Omimex Emergency Plugging Forms

OWP has a list of Omimex wells that require Emergency Plugging due to the high risk of an uncontrolled release. ECMC's LAS group has asked that we consult with CPW, based on the proximity to a Greater Prairie Chicken Production Area HPH, and the BLEDSOE 1-24-5-45 being within a Greater Prairie Chicken Lek Sites HPH.

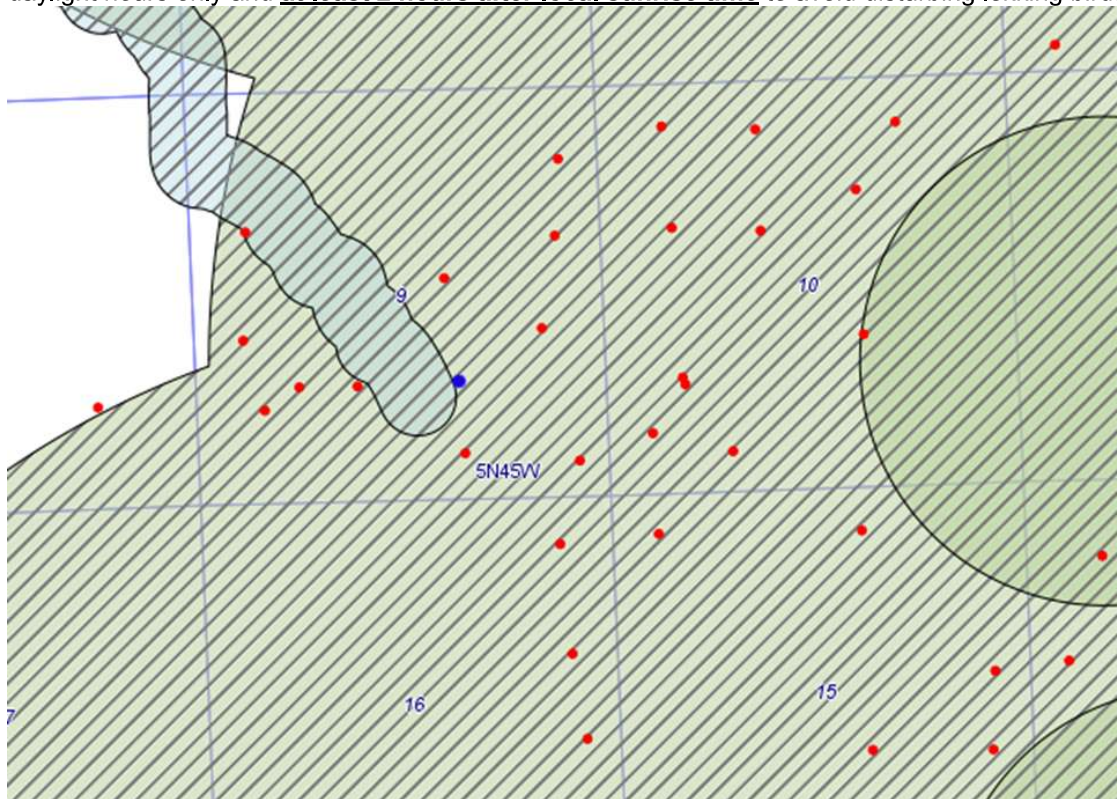
The first four wells are in GPC Production Area HPH and adjacent to Aquatic Native Species Conservation Waters HPH. The timing limitation for GPC PA HPH is: "No permitted or authorized human activities within 2.2 miles of a lek or from March 1 to June 30"

Due to the emergency nature of this effort, CPW's recommendation for these wells would be to conduct the work during daylight hours only and **at least 2 hours after local sunrise time** to avoid disturbing lekking birds.

Thank you for getting this out for our review. I agree that with stated exigent circumstances, the proposed procedure to start plugging activities 2 hours after local sunrise and only work during daylight hours will be acceptable.

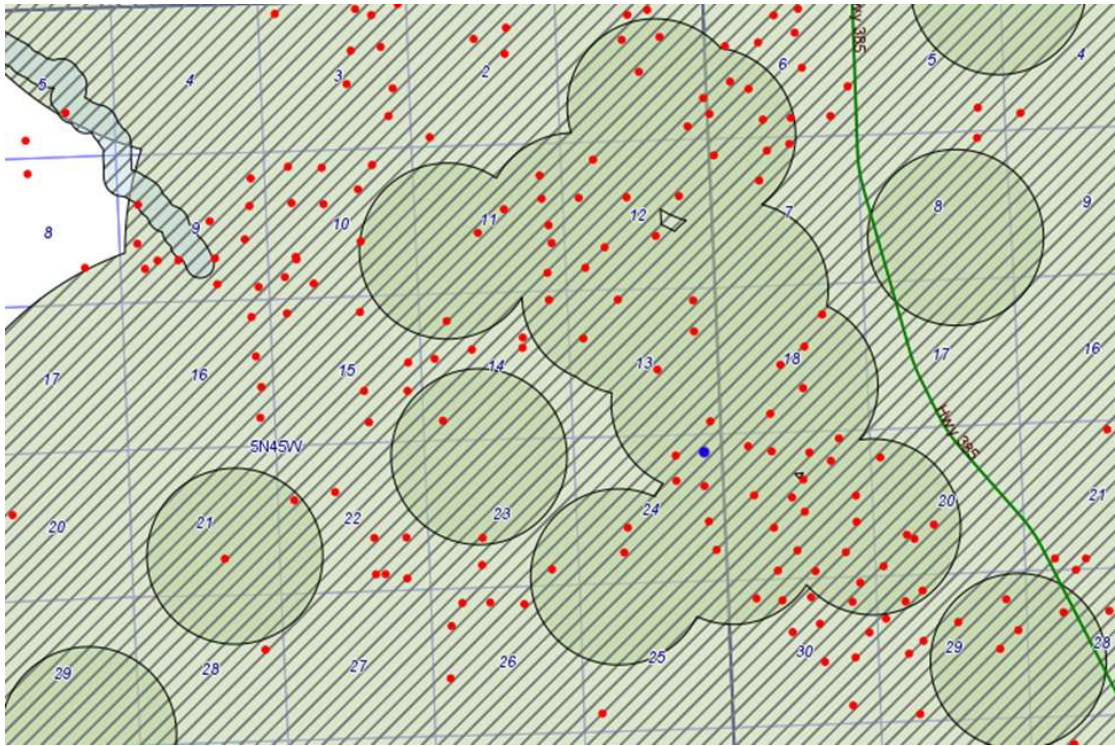
The Bledsoe 1-24-5-45 well is right in the middle of a GPC lek complex (blue dot on map). This HPH includes a year-round No Surface Occupancy (NSO) stipulation.

Due to the emergency nature of this effort, CPW's recommendation for this well would be to conduct the work during daylight hours only and **at least 2 hours after local sunrise time** to avoid disturbing lekking birds. Our Area 3 staff may have additional recommendations for resource protection measures due to the sensitive nature of this location.
